METRO PLANNING COMMITTEE OF THE TOWN PLANNING BOARD

MPC Paper No. 18/13 For Consideration by the Metro Planning Committee on 13.12.2013

FURTHER CONSIDERATION OF THE DRAFT PLANNING BRIEF FOR THE "COMPREHENSIVE DEVELOPMENT AREA" SITE <u>AT THE NORTH WEST KOWLOON RECLAMATION AREA SITE 6</u>

Plan 1	Location Plan
Plans 2 and 3	Site Plans
Plan 4	Aerial Photo
Plan 5	Site Photo
Plan 6	Development Concept Plan

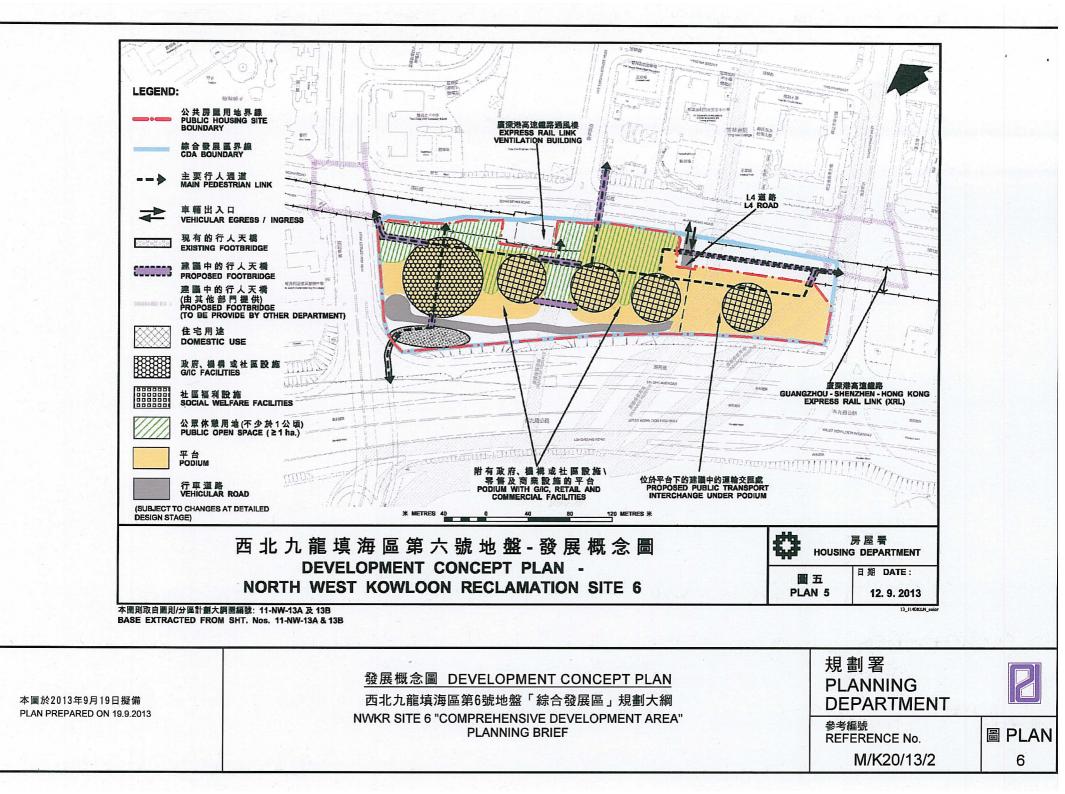
As noted from Housing Department (HD)'s revised indicative development scheme (**Plan 6** at **Appendix I**), with reduction in the number of residential blocks from 5 to 4, the increase in building height might cause adverse visual impacts to the surrounding area.

- (c) According to HD's Indicative Development Concept Plan (**Plan 6** at **Appendix I**), the proposed PTI will be partially decked over for construction of a residential block on top. In view of the concern on the internal air ventilation within the PTI, it is suggested to indicate in the revised draft PB (Item 16 on Traffic and Transport Aspects) that the PTI should be provided to the satisfaction of C for T and Director of Highways. The design of the PTI should make reference to EPD's Practice Note for Professional Persons for Control of Air Pollution in Semi-confined public transport interchange.

With regard to the concern on the visual impact from the proposed development with a maximum building height of 140mPD (as stipulated in the draft PB), the proposed building height is considered compatible with the Site's visual context and can be allowed, having regard to the building height profile of the existing and planned high-rise residential developments (such as Fu Cheong Estate, 'Four Little Dragons' and MTR Nam Cheong Station development) as well as the land requirements for the 22m wide non-building area and 1 ha of POS (**Plan 6** at **Appendix I**). In addition, a visual impact assessment (VIA) is required to be submitted as part of the MLP submission at the planning application stage to address potential visual impacts.

- (d) to stipulate that the provision of the PTI should be to the satisfaction of C for T and Director of Highways, and the design of the PTI should make reference to EPD's Practice Note for Professional Persons for control of air pollution in semi-confined PTI (ProPECC PN 1/98) (under Item 16 "Traffic and Transport Aspects").
